RE: Daviess County Bridge – Daviess County, Missouri
MoDOT Project BRO-B031(34)
Addendum No. 1

Addendum No. 1**Daviess County Bridge BRO-B031(34)
Daviess County, Missouri**

DAVISS COUNTY BRIDGE 35900061 BRO-B031(34)

INTERMEDIATE BENT DETAILS

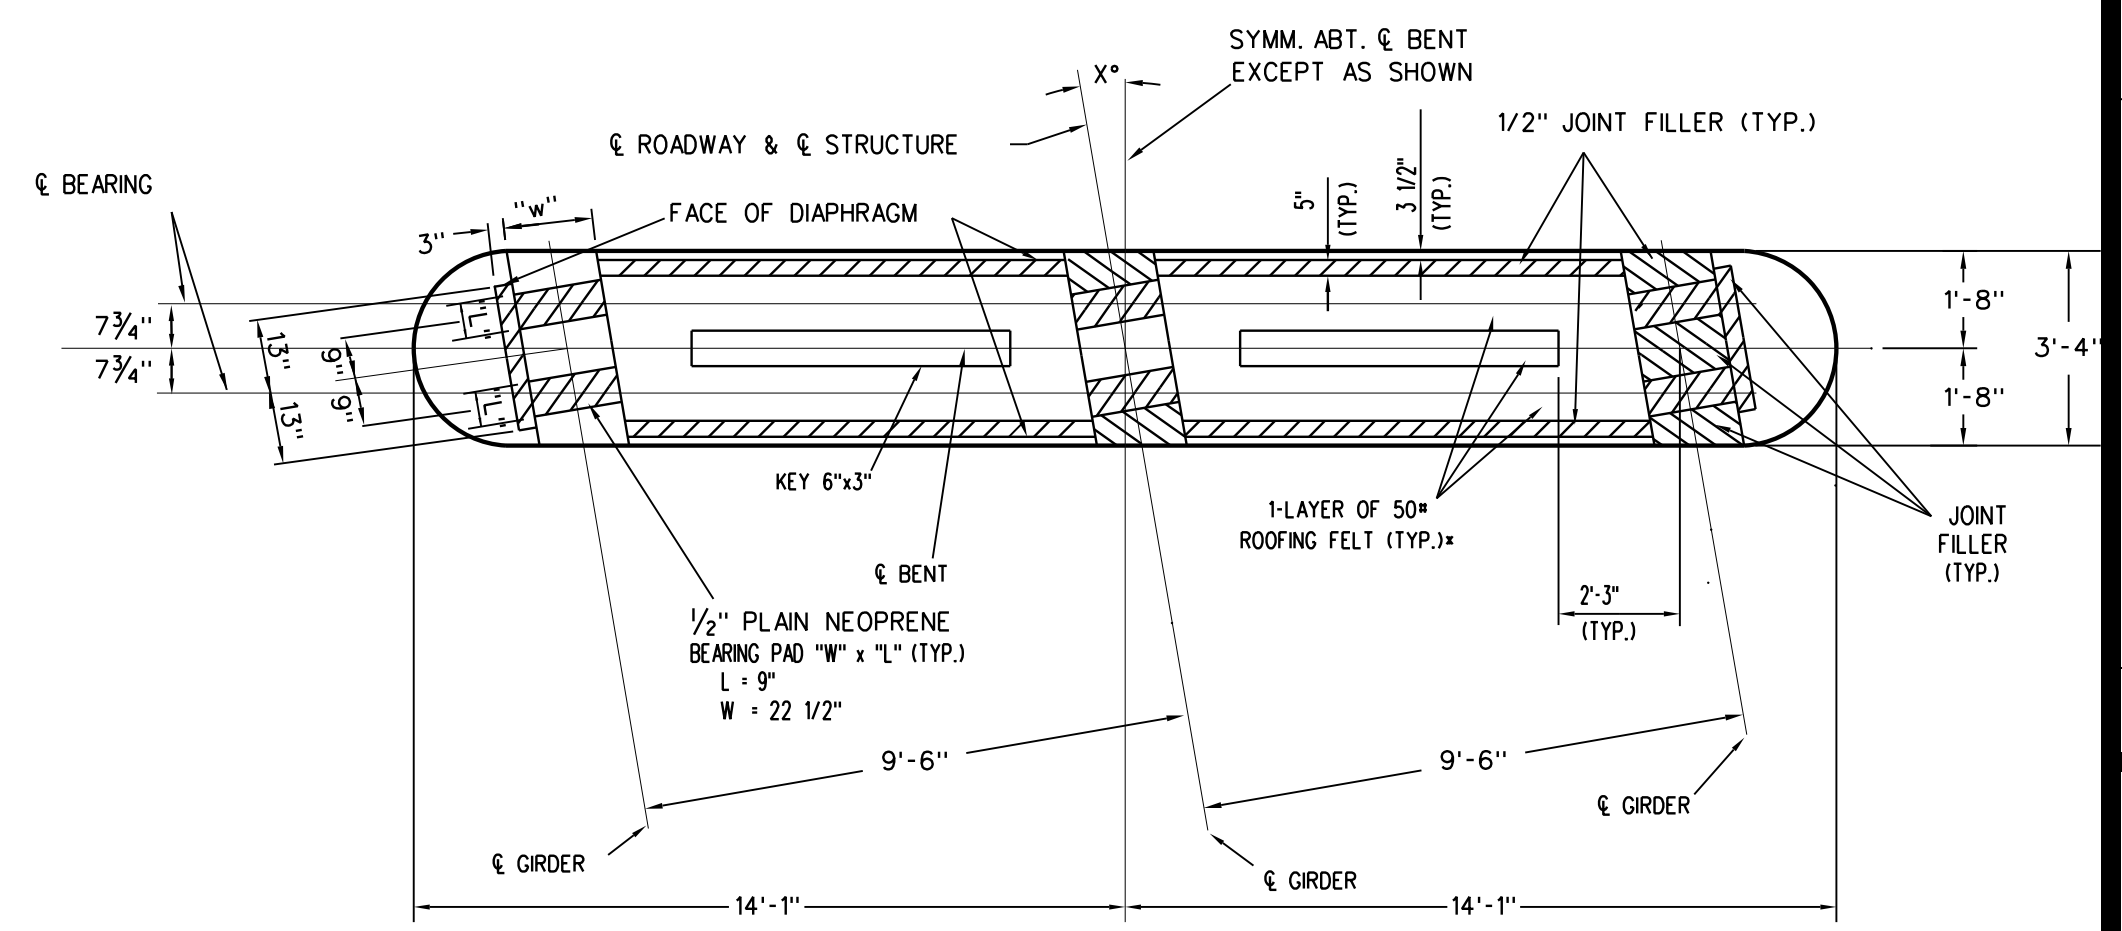
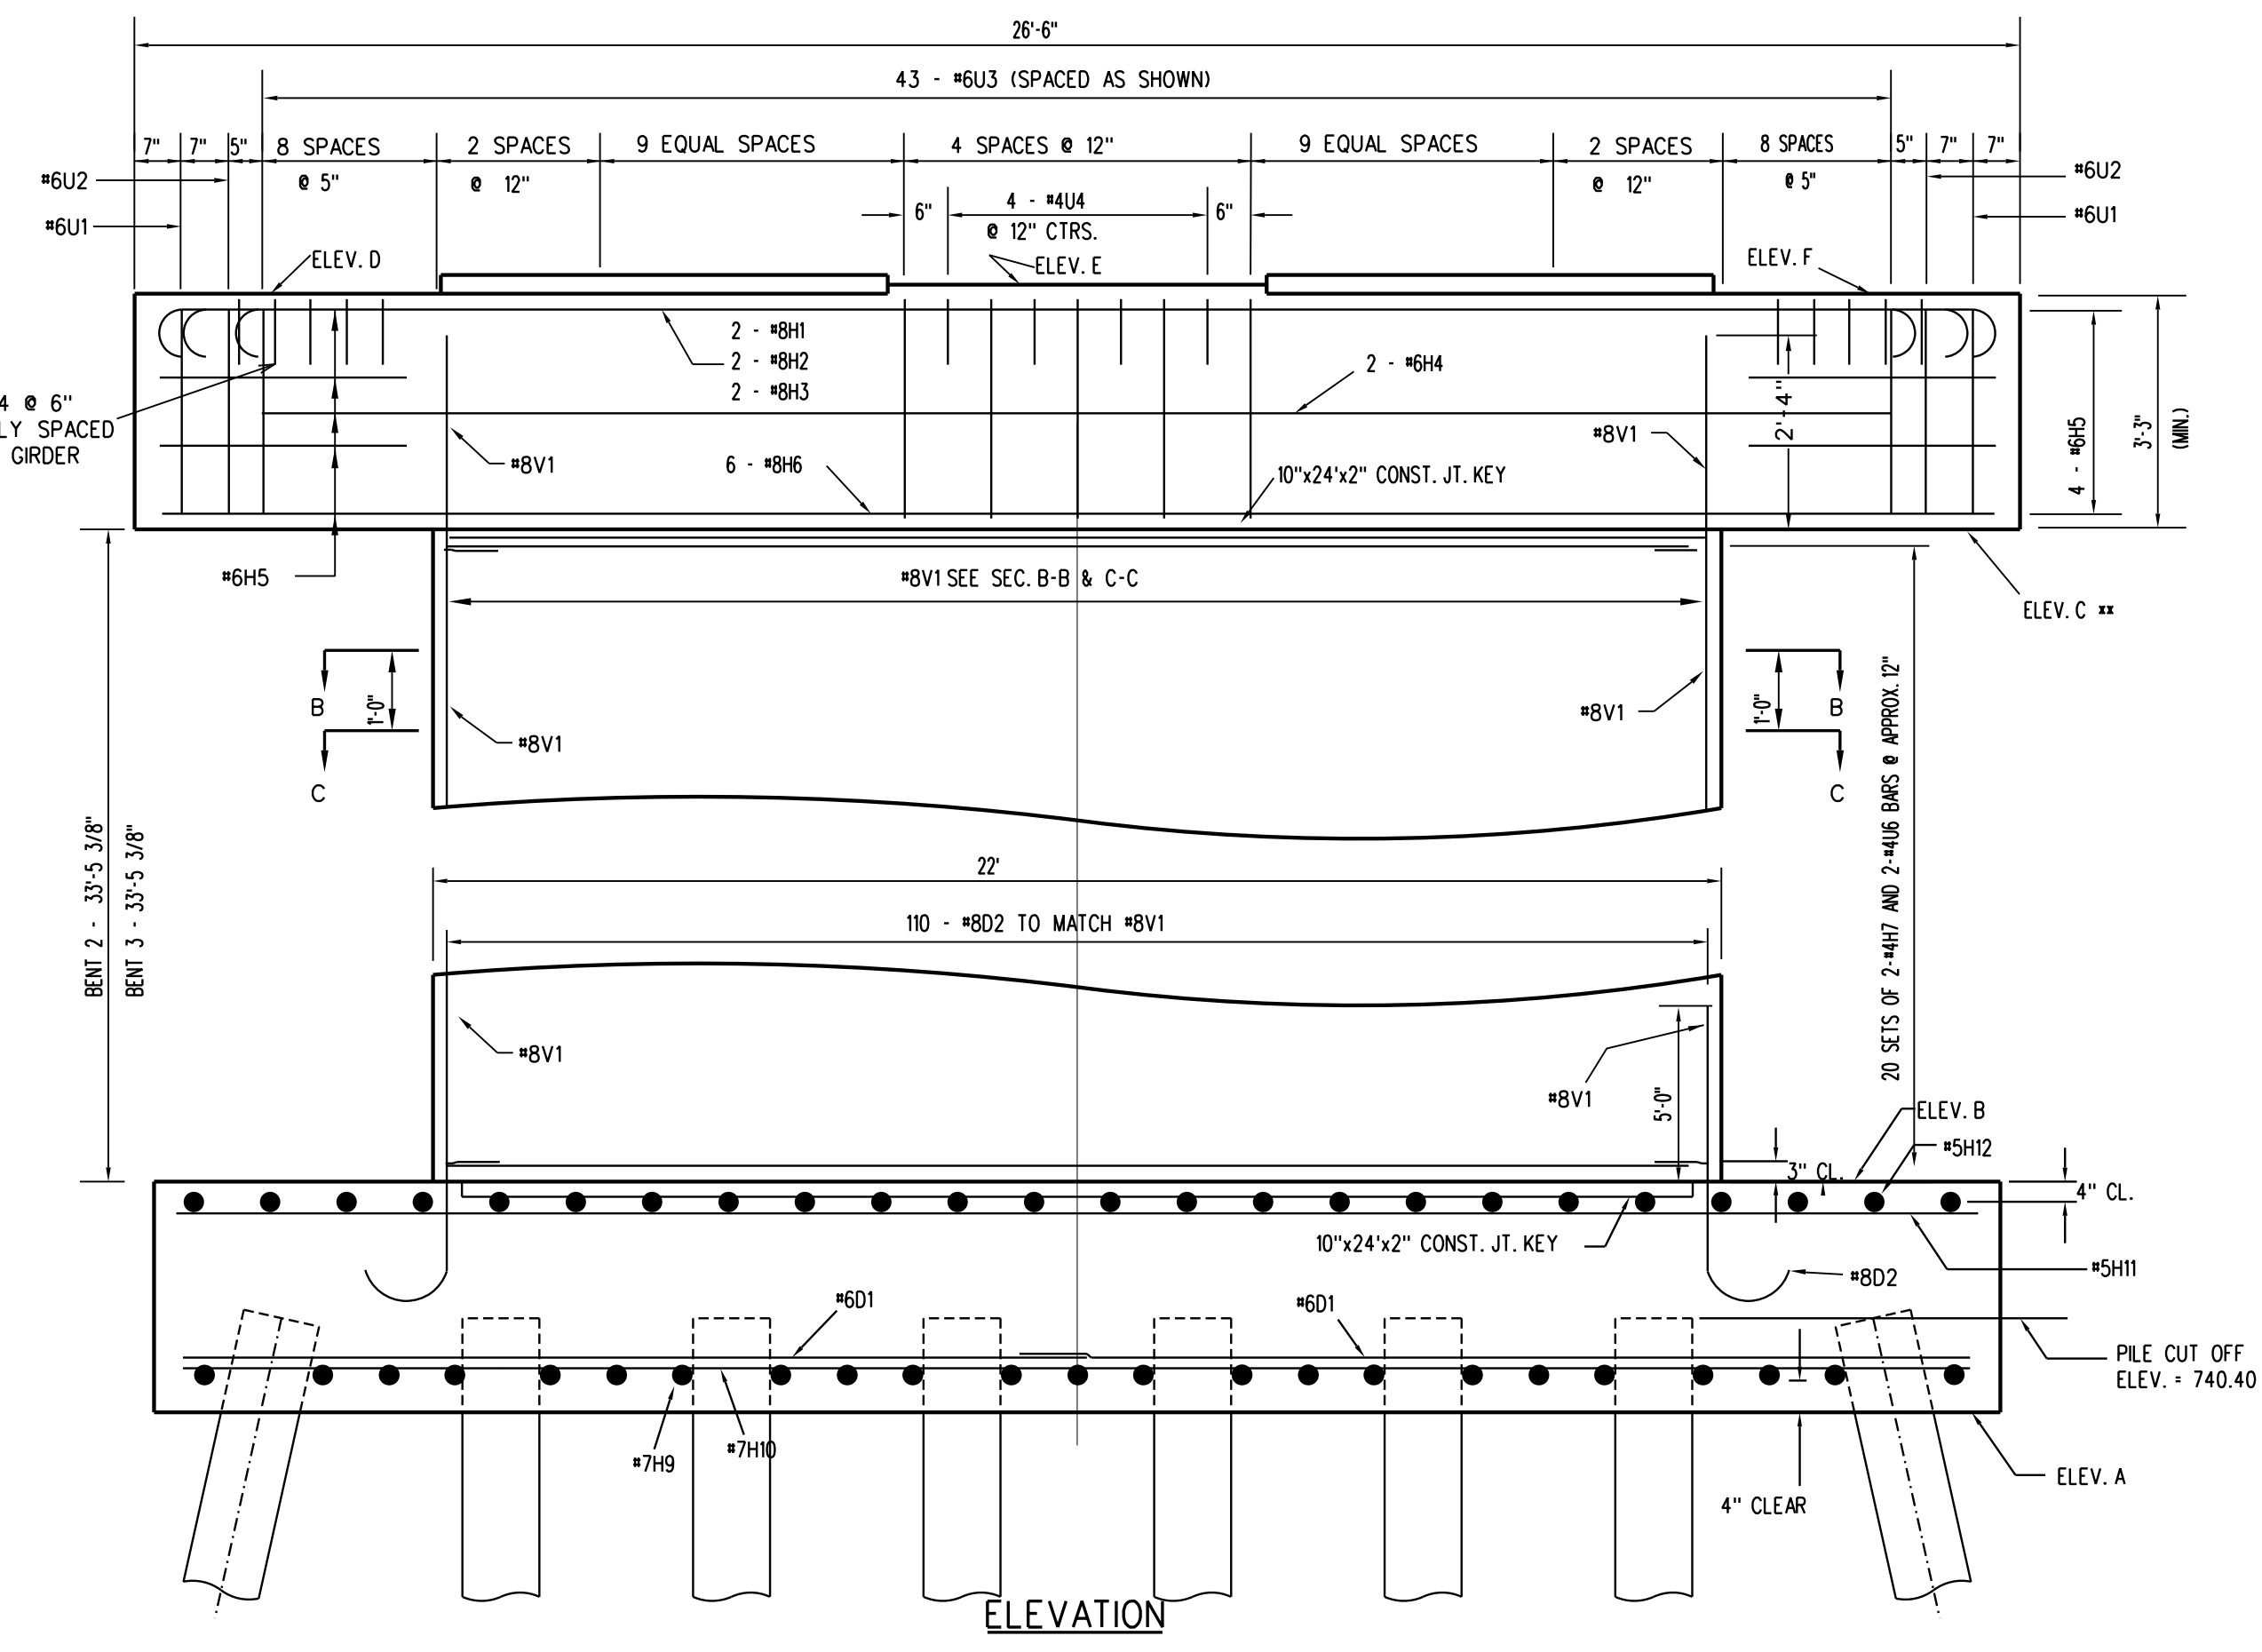
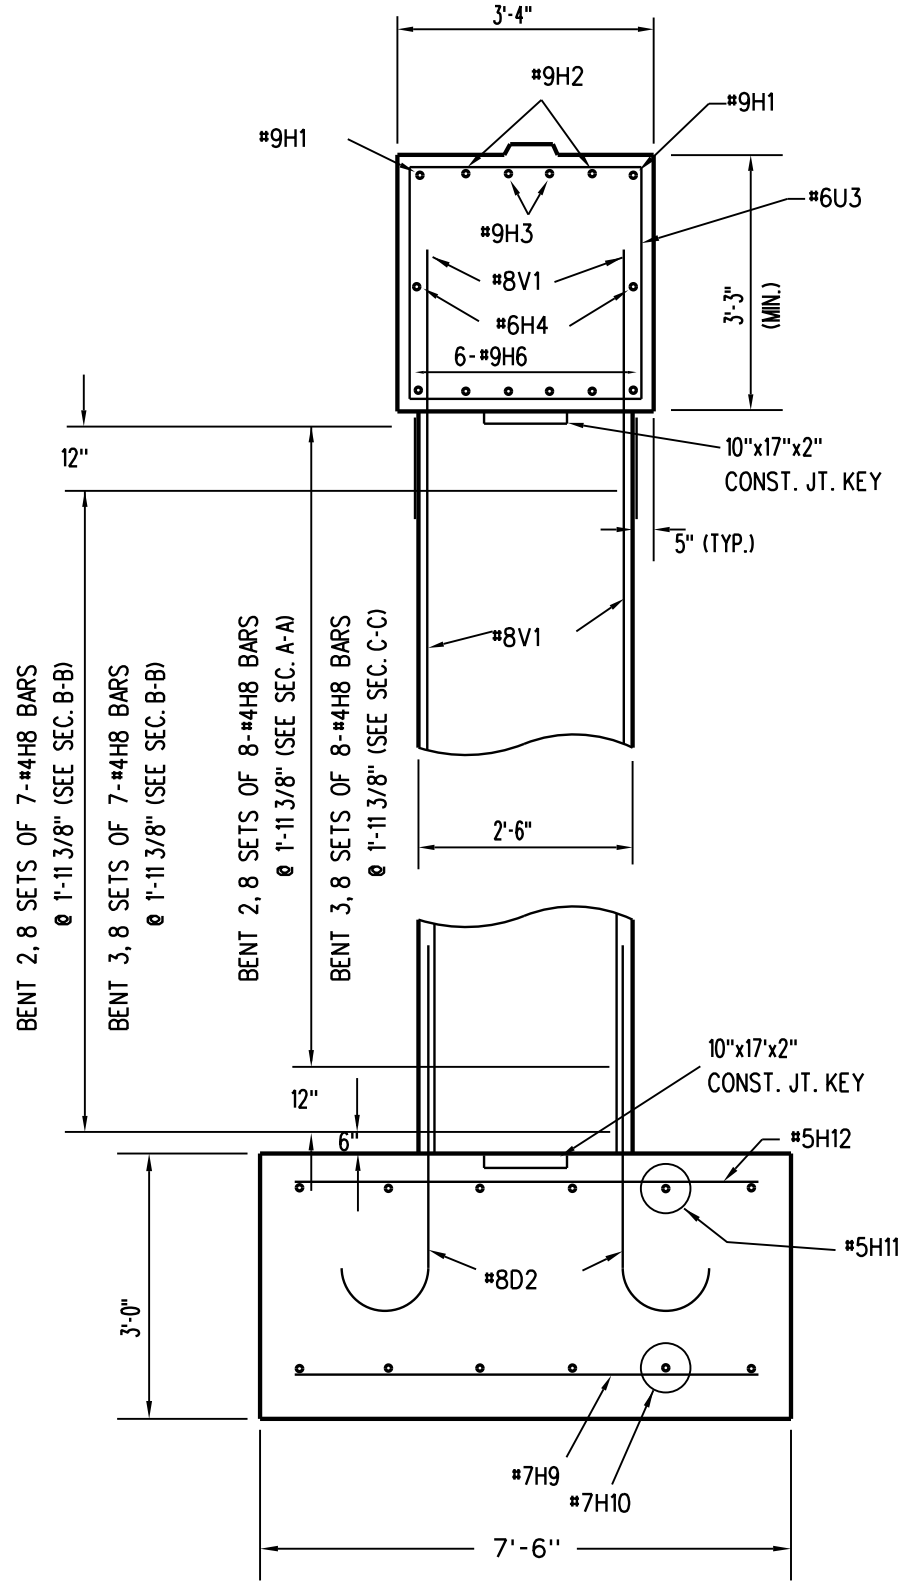
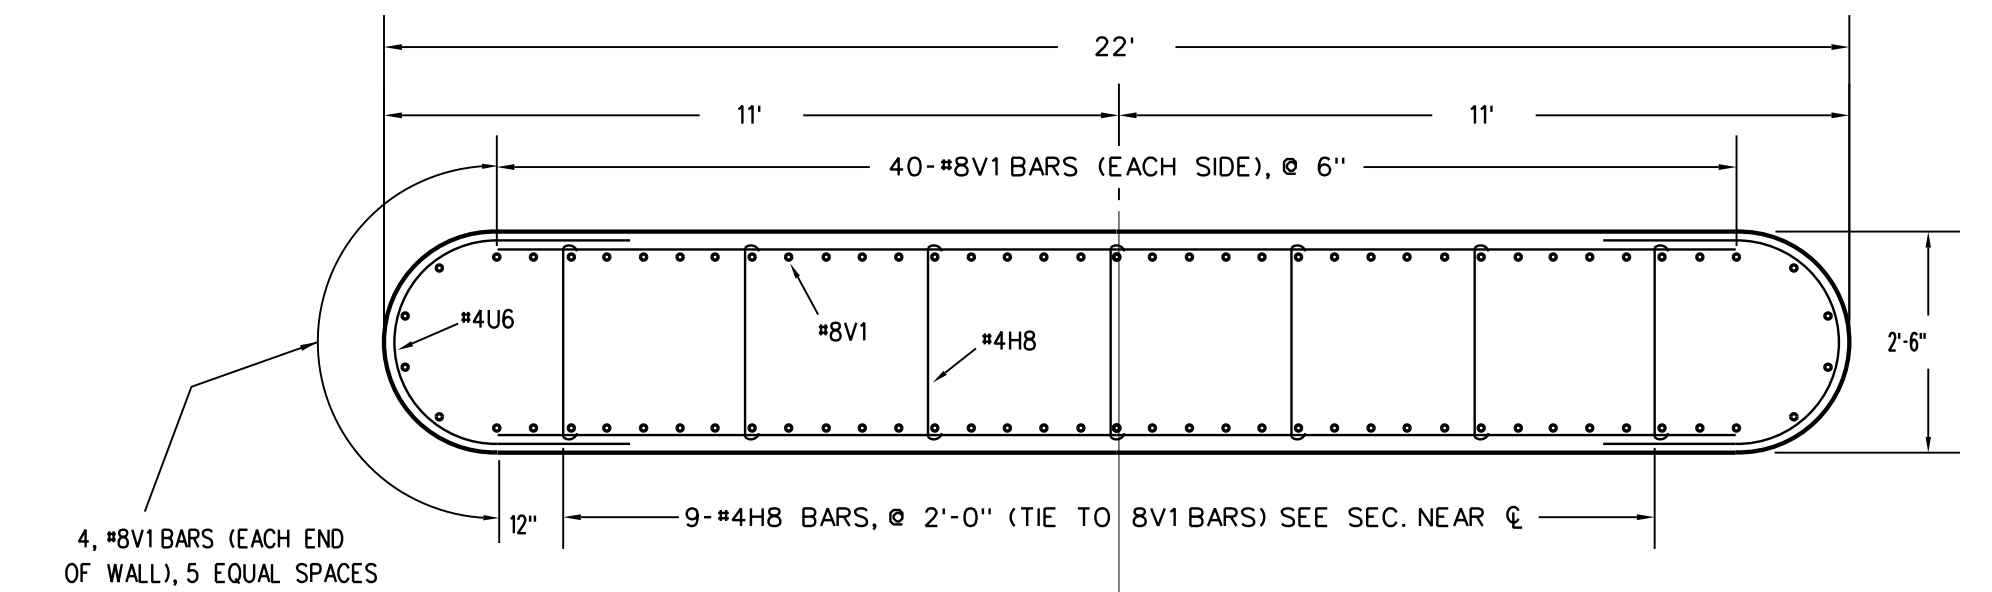
1. Replace sheet 6 of 22 with the enclosed. Elevation table has been corrected.
2. Attached you will find a complete replacement set of plans that are more legible. No other corrections have been made.

TABLE OF ELEVATIONS		
ELEVATION	BENT 2	BENT 3
A	738.90	738.90
B	741.90	741.90
C	775.35	775.35
D	778.60	778.60
E	778.73	778.73
F	778.60	778.60
